**CITY OF WESTOVER  
WESTOVER, WEST VIRGINIA  
SOLOMON ROAD IMPROVEMENTS**

**ADDENDUM #1**

**January 7, 2021  
Thrasher Contract #030-10222.00**

**TYPICAL BASE FAILURE REPAIR  
NOT TO SCALE**

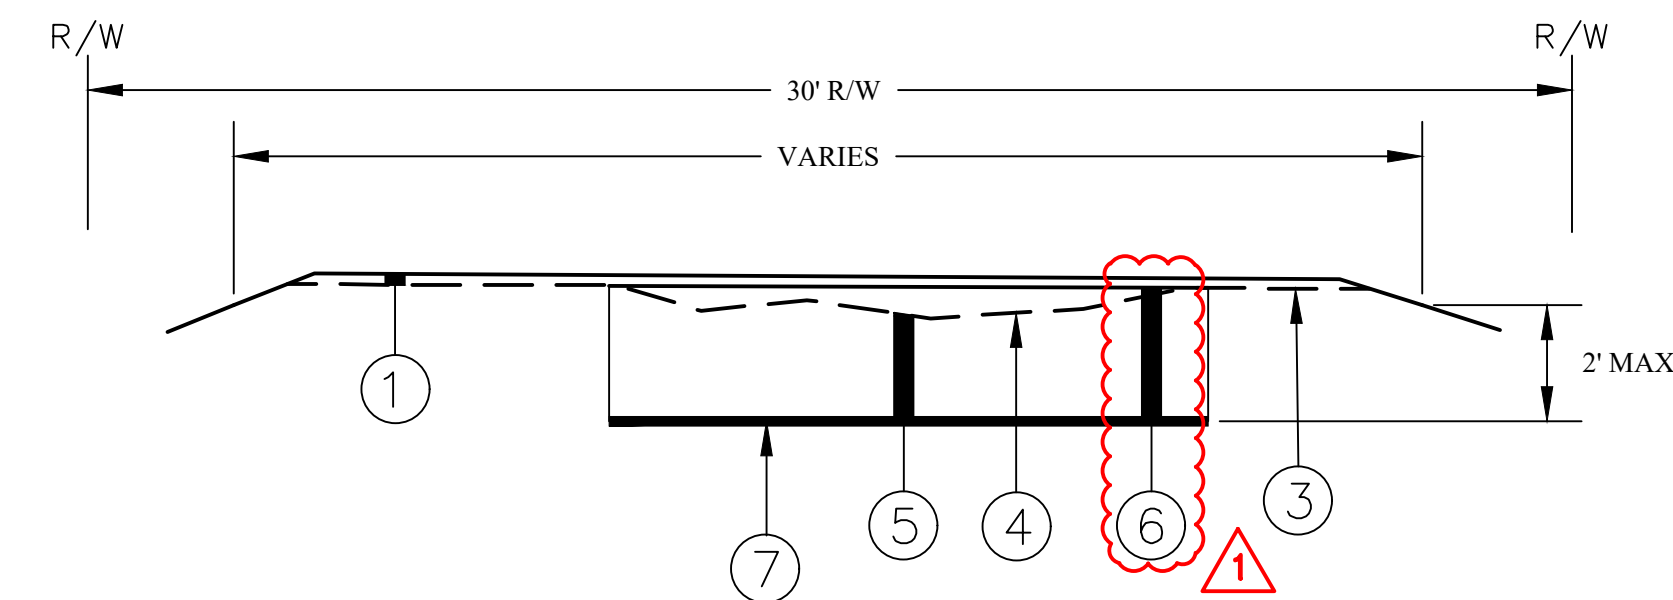
9. **QUESTION** – The paving will be done through the state purchase order program but the base failures in this contract does include putting in the base course of asphalt correct?

**RESPONSE** – *The Typical Base Failure Repair detail shown on plan sheet 12 was revised to replace the 3” layer of HMA Base Course, Type 2 with additional Aggregate Base Course, Class 9 and is provided with this Addendum. The Aggregate Base Course, Class 9 extends from the bottom of the excavation to the existing roadway surface.*

- NO. DESCRIPTION
- ① 1.5" HMA WEARING COURSE, TYPE 1 (CONTRACT 2)
- ② ~~3" HMA BASE COURSE, TYPE 2 (CONTRACT 2)~~
- ③ EXISTING ROADWAY
- ④ BASE FAILURE AREA
- ⑤ 2' MAXIMUM OF UNCLASSIFIED EXCAVATION
- ⑥ 2' MAXIMUM OF AGGREGATE BASE CLASS 9
- ⑦ FABRIC FOR SUBGRADE STABILIZATION

NOTE:  
1. EXCAVATE BOTTOM OF FAILURE TO DEPTH OF SUITABLE MATERIAL, AS DIRECTED BY THE ENGINEER  
2. UNDERCUTS FOR BASE FAILURE SHALL BE 2' MAXIMUM  
3. EACH COURSE SHALL BE ROLLED AND COMPACTED IN NO GREATER THAN 4 INCH LIFTS
